TOP DRIVE
PRODUCT BULLETINS

CANRIG TD PRODUCT BULLETIN MANUAL

CANRIG DRILLING TECHNOLOGY LTD

Fig. 2

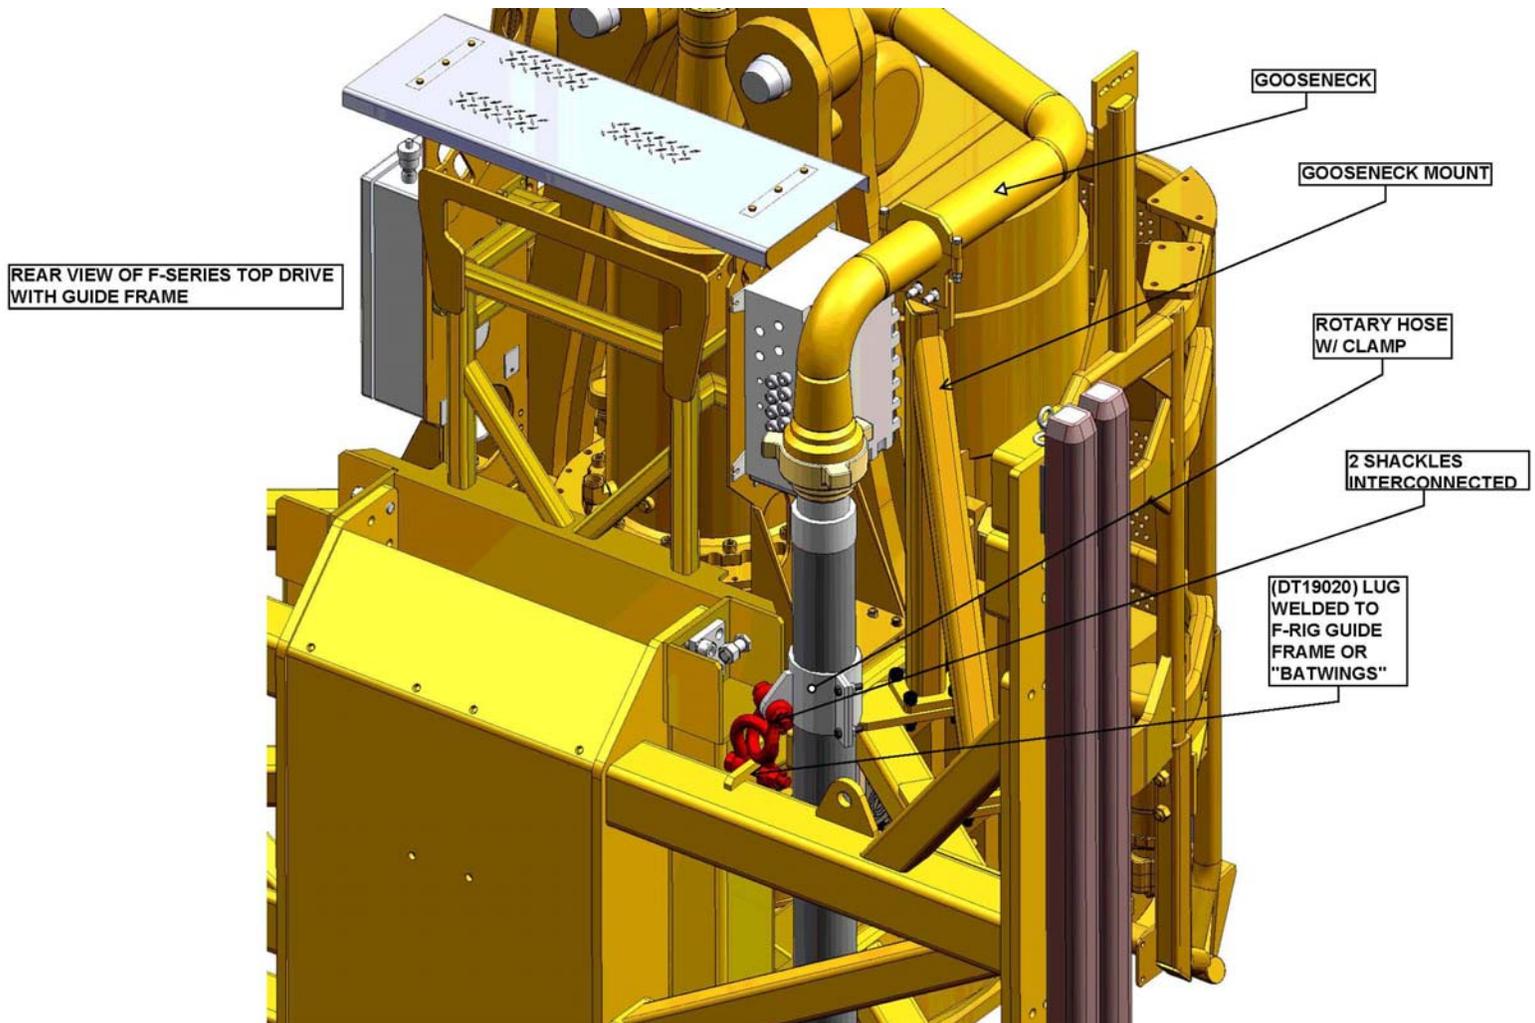
1. Refer to included drawing (DT19021).
2. Weld lug (DT19020) to F-rig Guide Frame based on specifications shown in the modification drawing (DT19021).
3. Interconnect (2) shackles (supplied by customer) between Rotary Hose Clamp and the lug (DT19020) welded to the F-rig Guide Frame as shown in Fig. 2.

Fig. 3

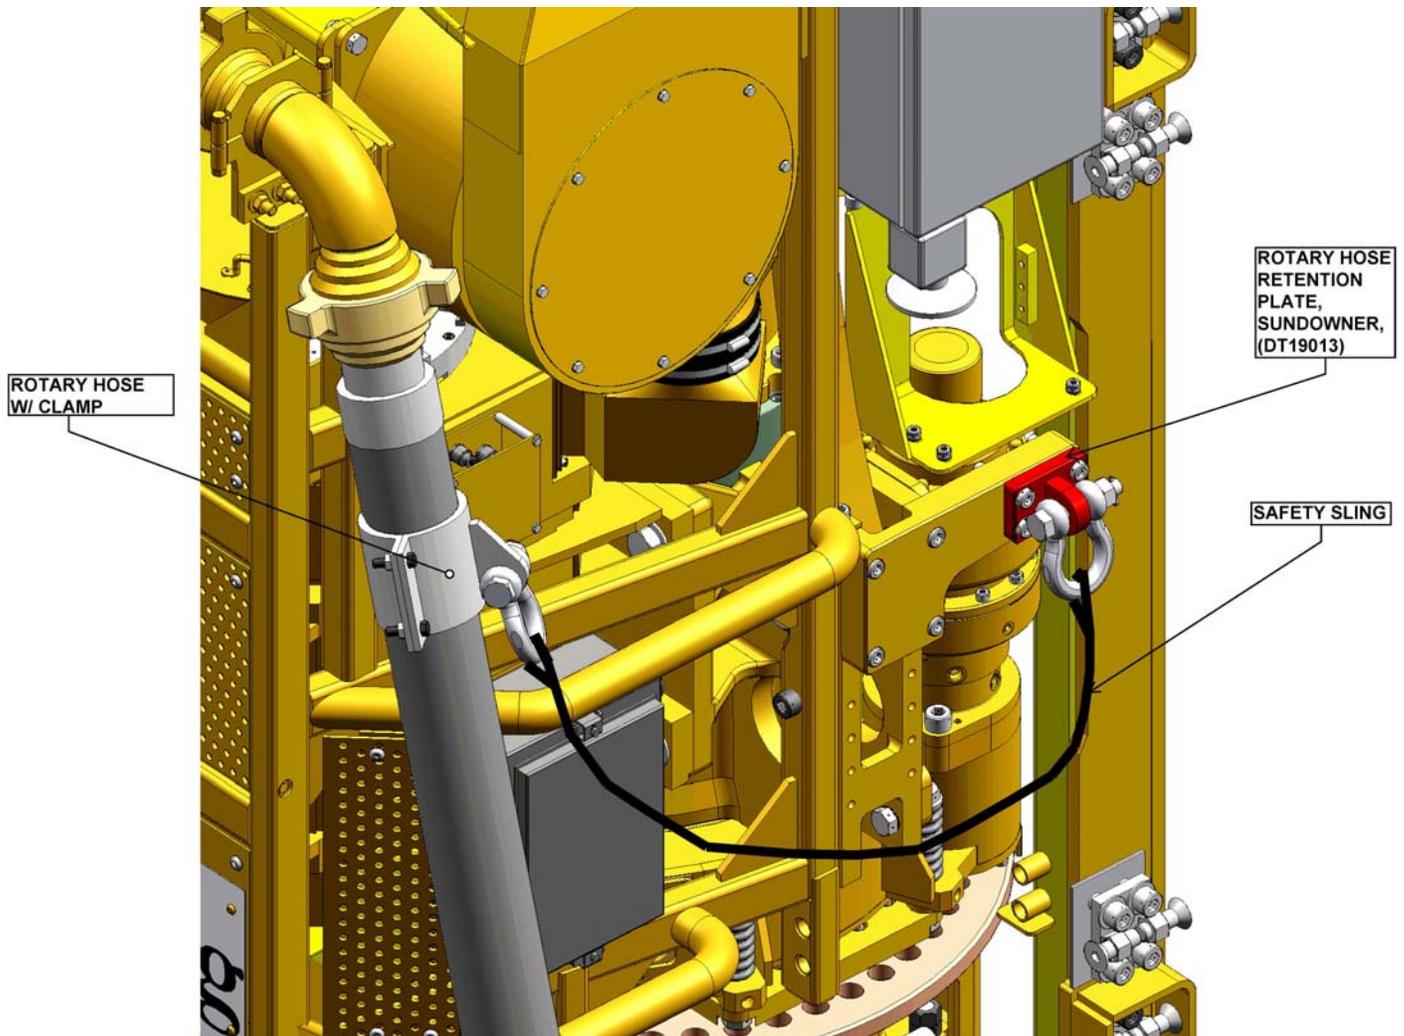
1. Remove existing (4) $\frac{3}{4}$ "-10UNC capscrews from existing Connector Plate and replace with Rotary Hose Retention Kit (AY16685) for Sundowner which includes Rotary Hose Retention Plate (DT19013) with longer $\frac{3}{4}$ "-10UNC x $3\frac{1}{2}$ " (SH-0750NC-0350-W) capscrews and (4) Nordloc washers (LW-0750-NLS). Rotary Hose Retention Plate is installed on top of the existing Connector Plate. See Fig. 3.

Fig. 1

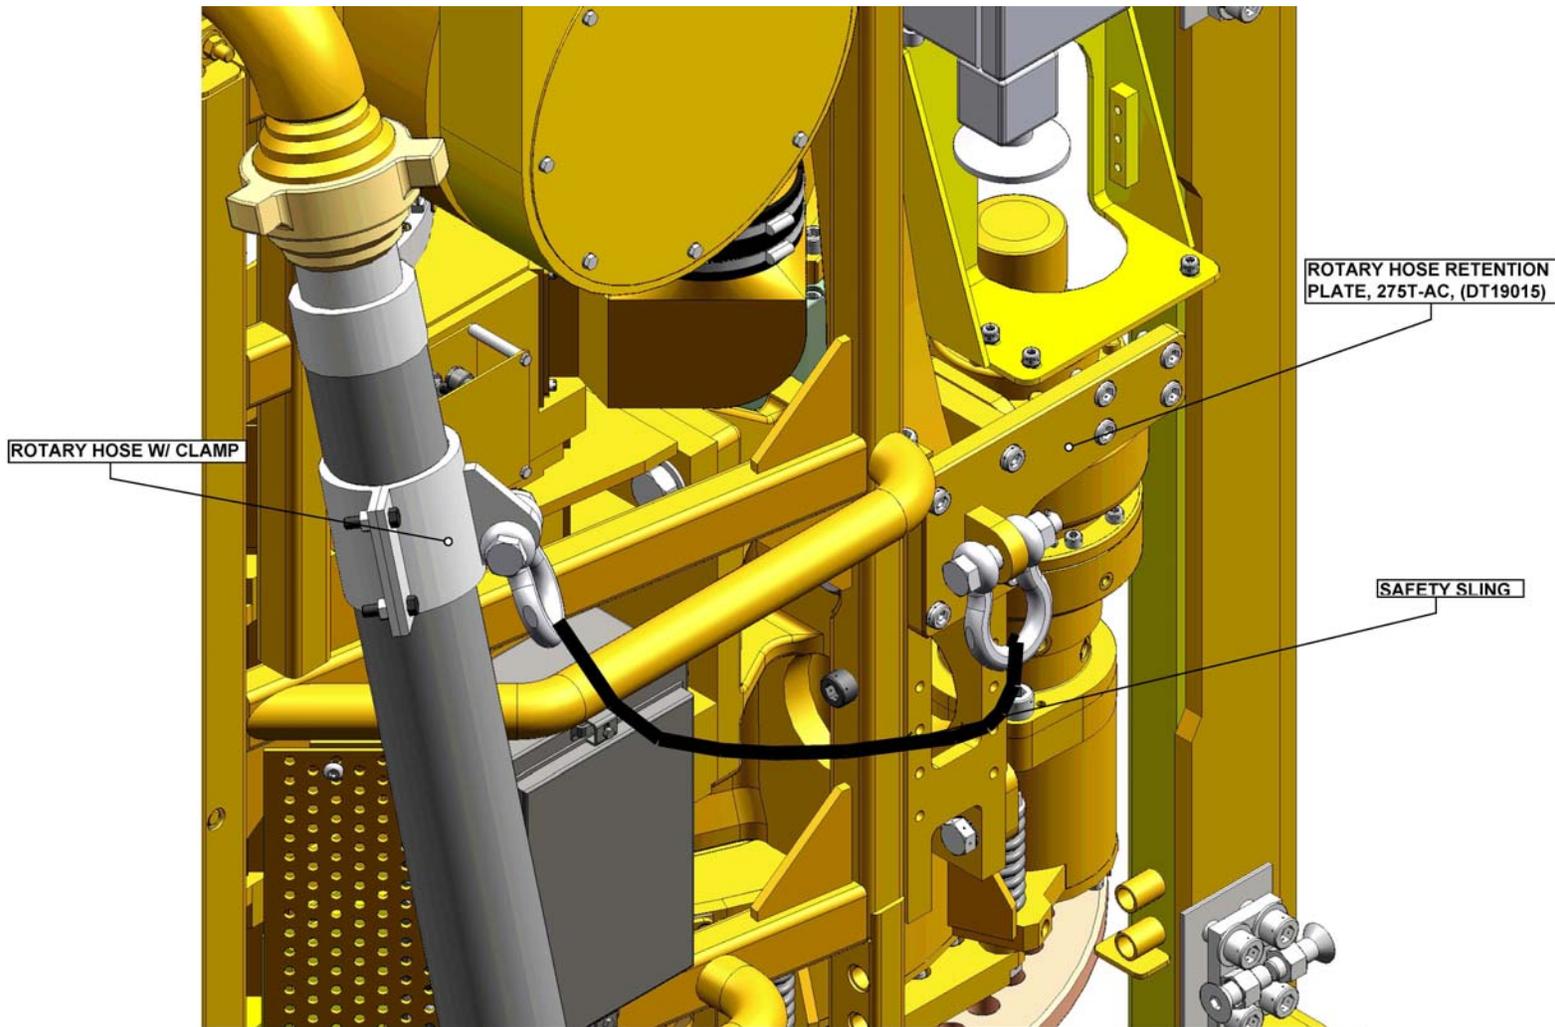
1. Remove existing Connector Plate with (8) 3/4"-10UNC capscrews and replace with Rotary Hose Retention Kit (AY16643) for 275T-AC Top Drive which includes Rotary Hose Retention Plate (DT19015) with (8) 3/4"-10UNC x 1 1/4" (SH-0750NC-0125-W) capscrews and (8) Nordloc washers (LW-0750-NLS). See Fig. 1.
2. Torque the (8) 3/4"-10UNC x 1 1/4" LG capscews to 350 ft-lbs and safety wire with (M21-2000-010) and (M19-3006-010).
3. Install one end of sling to shackle and attach to lug in Rotary Hose Retention Plate (DT19015). (Sling and shackle supplied by customer.)
4. Install other end of sling to other shackle and install on the Rotary Hose Clamp. Tie-wrap slings to eliminate excess slack with (E03-2000-010). Final assembly should be as shown in Fig. 1.

Fig. 1

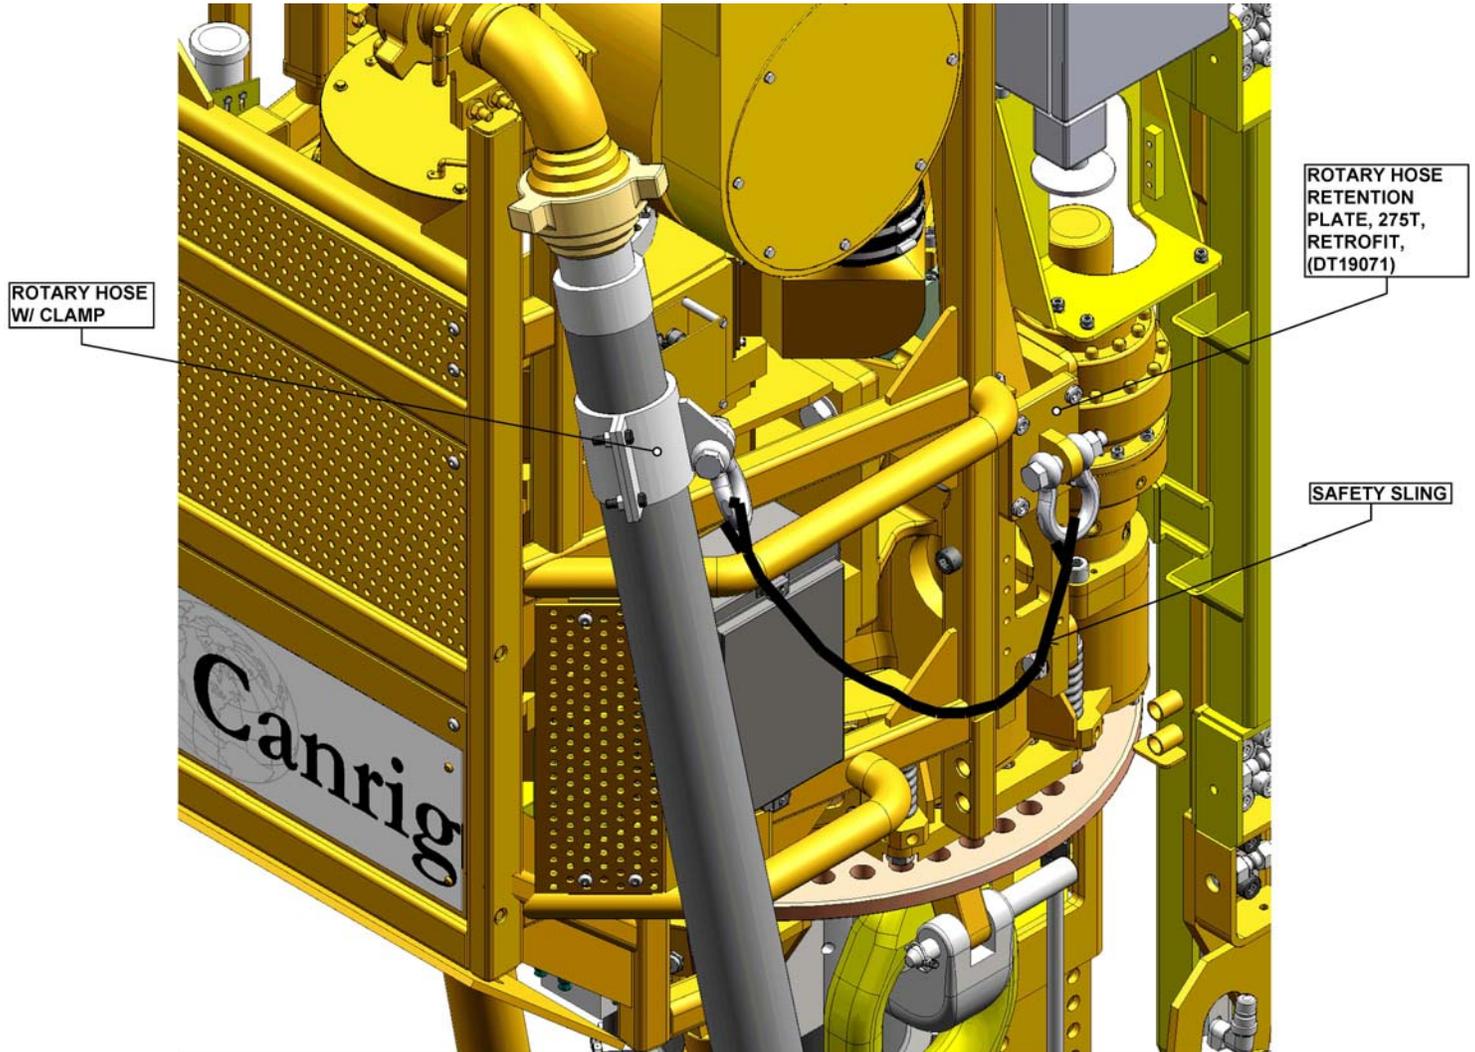
1. Refer to included drawing (DT19072) for Top Drive Housing modification to drill and tap (4) holes at specified dimensional location in drawing. See Fig. 1.
2. After holes are tapped, install Rotary Hose Retention Plate (DT19071) with (4) 3/4"-10UNC x 1 1/4" (SH-0750NC-0125-W) capscrews and (4) Nordloc washers (LW-0750-NLS).
3. Torque the (4) 3/4"-10UNC x 1 1/4" (SH-0750NC-0125-W) capscrews to 350 ft-lbs and safety wire with (M21-2000-010) and (M19-3006-010).
4. Install one end of sling to shackle and attach to lug in Rotary Hose Retention Plate (DT19071). (Sling and shackle supplied by customer.)
5. Install the other of sling to shackle and attach on the Rotary Hose Clamp. Tie-wrap slings to eliminate excess slack with (E03-2000-010). Final assembly should be as shown in Fig 1.

Fig. 2

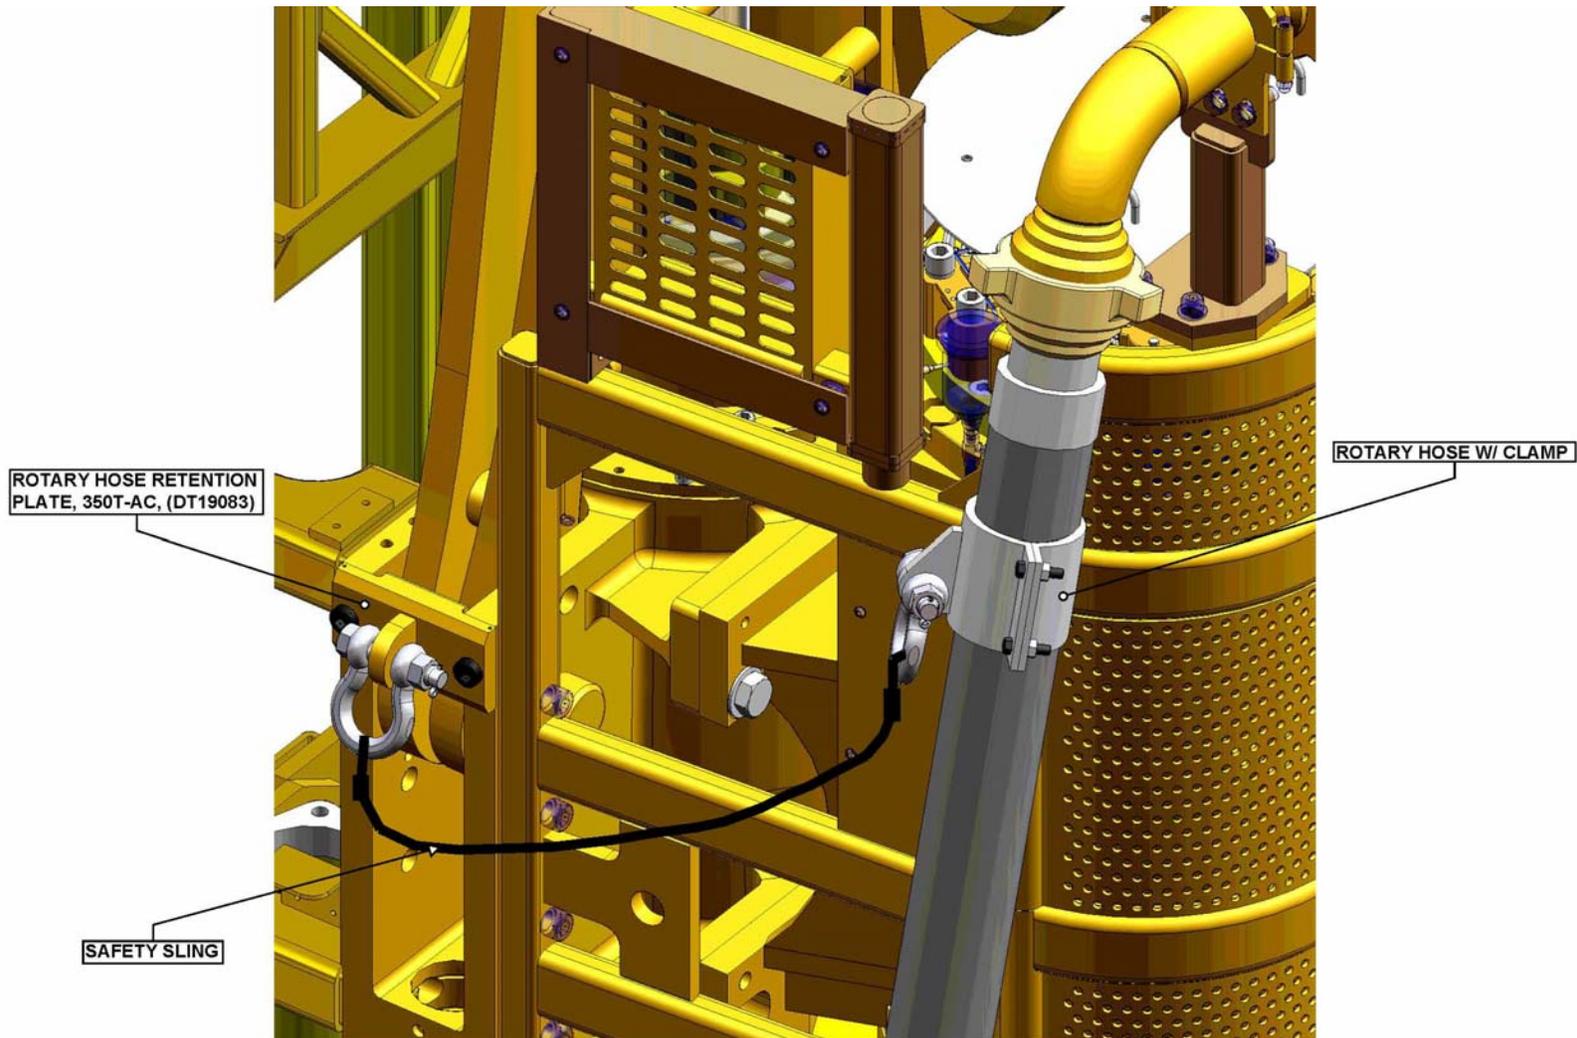
1. Refer to included drawing (DT19084) for Top Drive Housing Modification to drill and tap (2) holes at specified dimensional location in drawing. See Fig. 2.
2. After holes are tapped, install Rotary Hose Retention Plate (DT19083) with (2) 1"-8UNC x 2" (SH-1000NC-0200-W) capscrews and (2) Nordloc washers (LW-1000-NL).
3. Torque the (2) 1"-8UNC x 2" (SH-1000NC-0200-W) capscrews to 848 ft-lbs and safety wire with (M21-2000-010) and (M19-3006-010).
4. Install one end of sling to shackle and attach to lug in Rotary Hose Retention Plate (DT19083). (Sling and shackle supplied by customer.)
5. Install the other of sling to shackle and attach on the Rotary Hose Clamp. Tie-wrap sling to eliminate excess slack with (E03-2000-010) Final assembly should be as shown in Fig 2.

Fig. 3

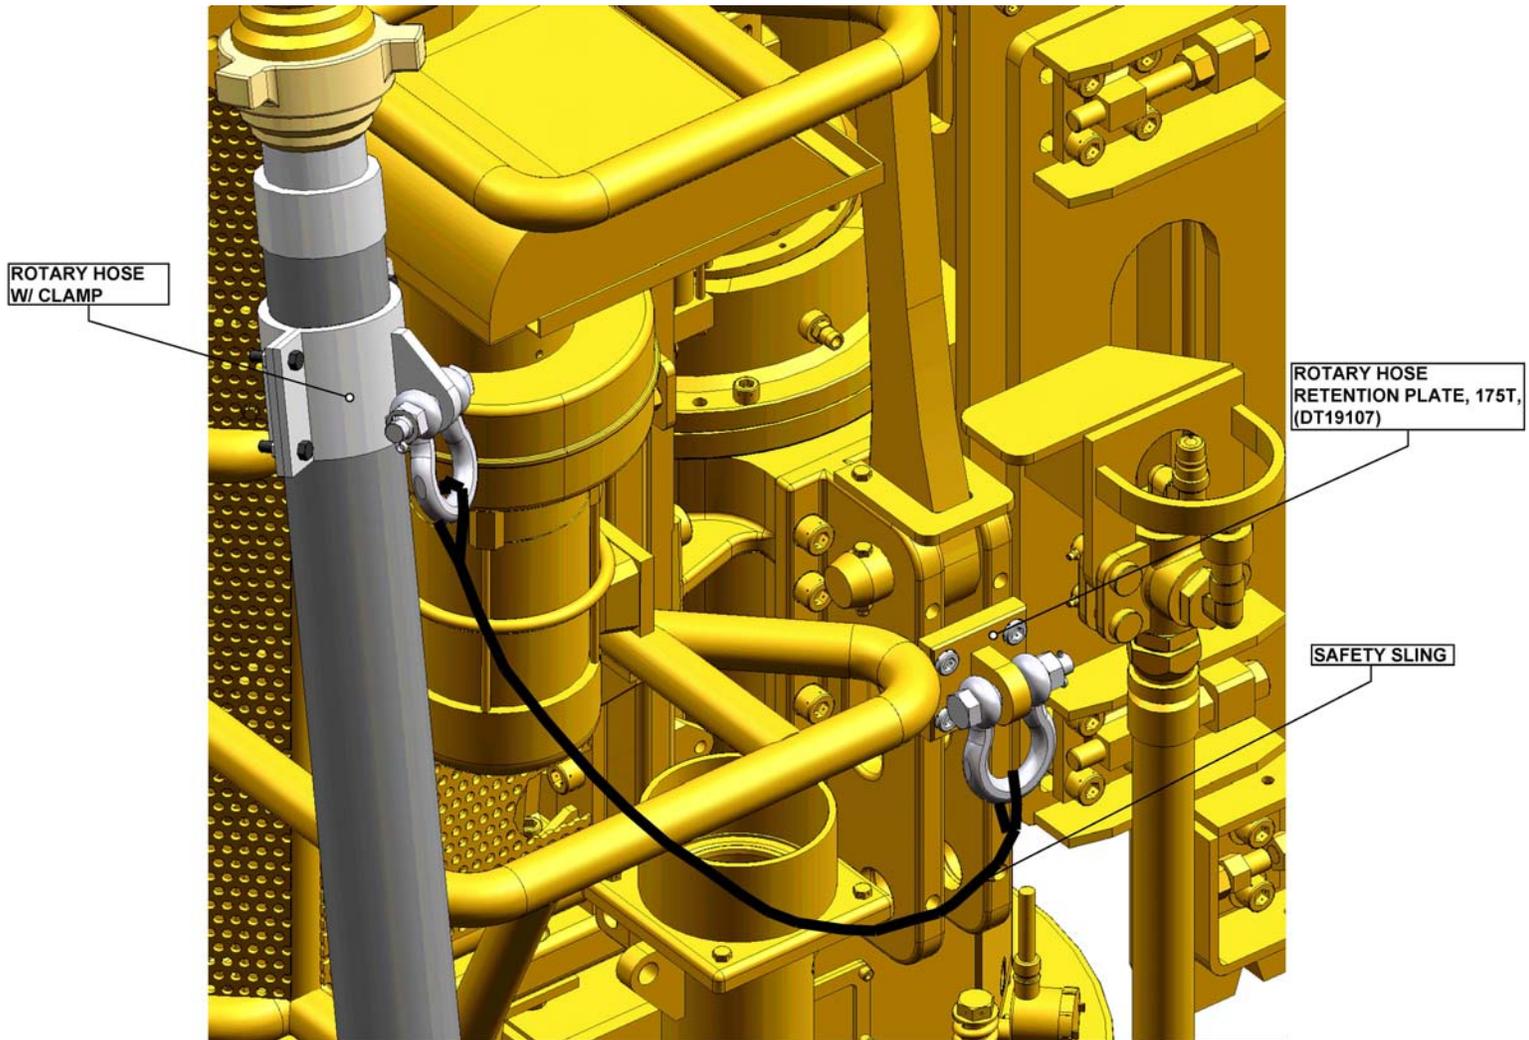
1. Refer to included drawing (DT19121) for Top Drive Housing modification to drill and tap (4) holes at specified dimensional location in drawing. See Fig. 3.
2. After holes are tapped, install Rotary Hose Retention Plate (DT19107) with (4) 3/4"-10UNC x 1 1/4" (SH-0750NC-0125-W) capscrews and (4) Nordloc washers (LW-0750-NLS)
3. Torque the (4) 3/4"-10UNC x 1 1/4" (SH-0750NC-0125-W) capscrews to 350 ft-lbs and safety wire with (M21-2000-010) and (M19-3006-010).
4. Install one end of sling to shackle and attach to lug in Rotary Hose Retention Plate (DT19107) . (Sling and shackle supplied by customer.)
5. Install the other of sling to shackle and attach on the Rotary Hose Clamp. Tie-wrap slings to eliminate excess slack with (E03-2000-010). Final assembly should be as shown in Fig 3.
